# UNITED STATES NUCLEAR REGULATORY COMMISSION

DOCKET NO: 50-410

SUBCOMMITTEE ON NINE MILE POINT NUCLEAR  
STATION, UNIT NO. 2

DATE: THURSDAY, FEBRUARY 21, 1985

1. DRUM, MAIN: DESIGNED SO THAT UPON FAILURE OF DRUM SHAFT OR BEARING, THE DRUM GEAR WILL REMAIN ENGAGED

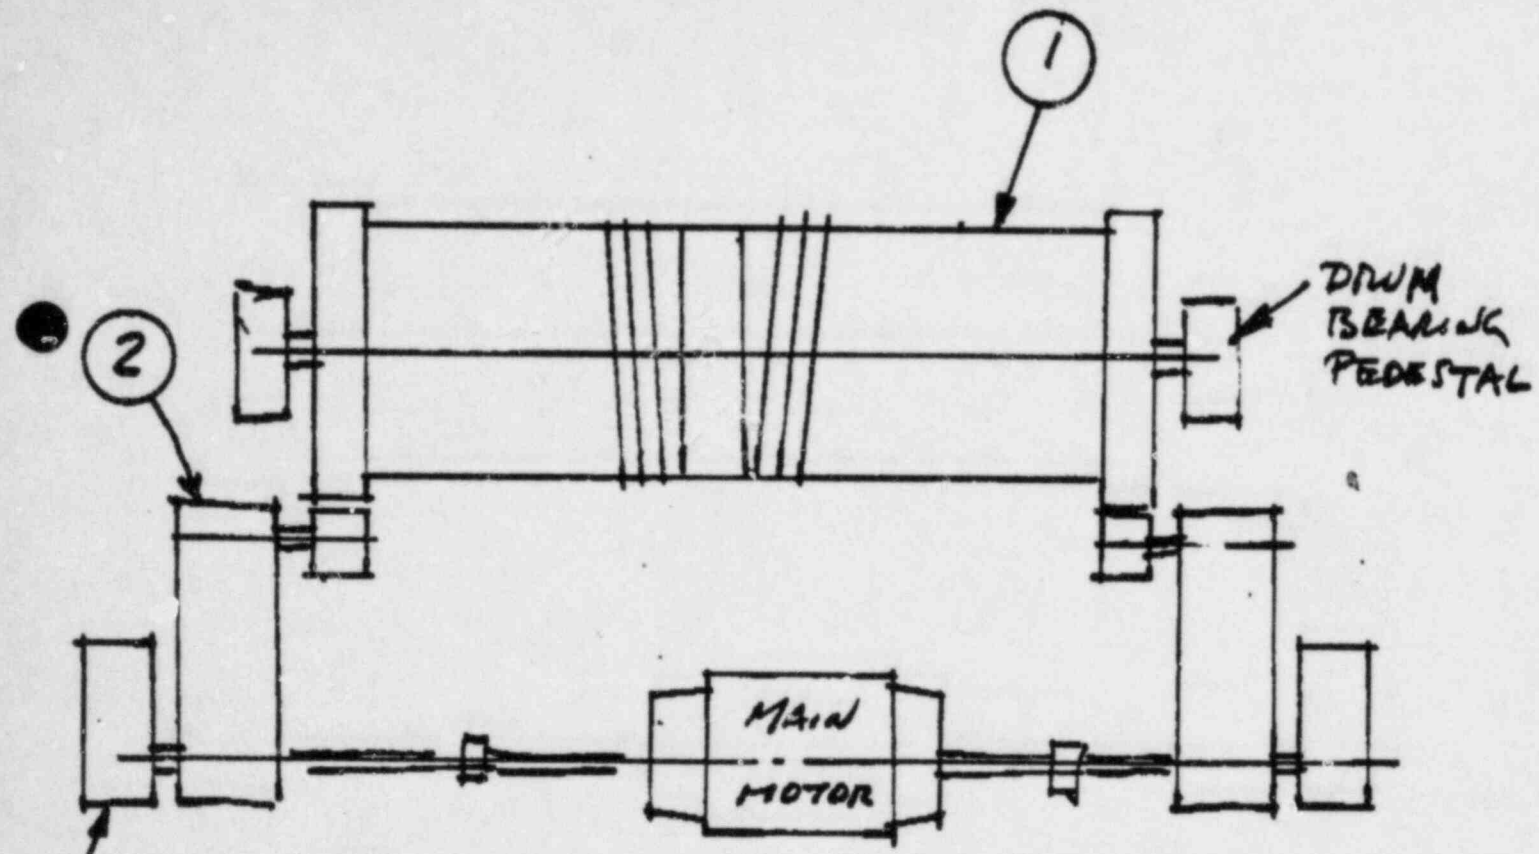
12 MR. EBERSOLE: May I ask a sometimes little  
13 obscure question. The main motor has a certain ultimate  
14 torque rating. It is positioned in the limits of its travel  
15 or load by switches, position switches or torque switches  
16 or load switches.

6 MR. EBERSOLE: Now that raises the eternal  
7 question, do you know when the first limit switch fails in  
8 order for you to go repair it and keep redundance?

3 This sketch is a planned view of the crane drum,  
4 gearing, hoist motor and brakes.

23 MR. KLEIN: I am not sure how to answer your  
24 question. The motor has an overspeed control over it and  
25 the brakes will lock on overspeed.

20 MR. ALLEN: No, it does not. To answer your  
21 question on limit switches, there are two limit switches,  
22 one set just right after the other, and we do periodically  
23 verify their operation.
